Access Compliance Report Public Rights-of-Way (RR Crossings)

Intersection ID: 10025310	Main Street: E_5TH_ST	Location:	N/A
ADA ID: C1A3D31BC835	Overall Compliance: No	Severity Score:	0.0
Codes/Mitigation Info/Possible Solution		Field Measurements/Component Compliance

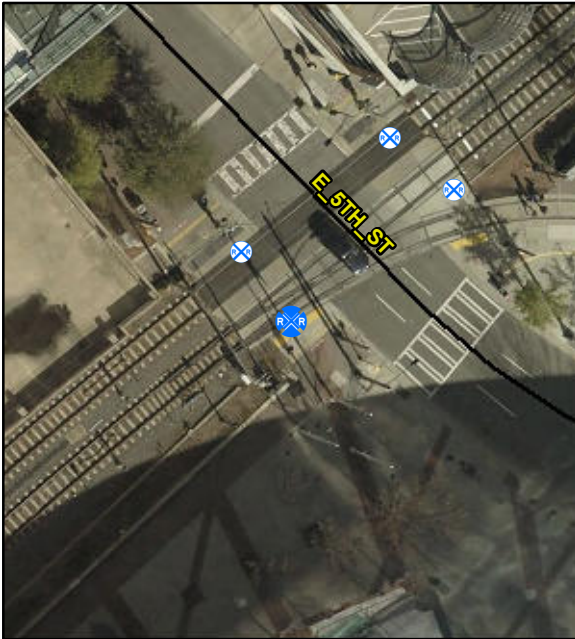
Remove & Replace Detectable Warning System. Provide Pedestrian Gate. Remove & Replace Walking Surface Adjacent to Rail.

Compliance	Description	Data
Yes	DWS Provided?	Yes
Yes	DWS Contrast?	Yes
Yes	DWS Width (in)	Yes
Yes	DWS Length (in)	25
No	DWS Offset (in)	15
No	Pedestrian Gate?	No
N/A	DWS Outside Gate?	N/A
N/A	Rail Type?	LightRail
No	Flangeway Gap (in)	3
Yes	Sidewalk Width (in)	190.0
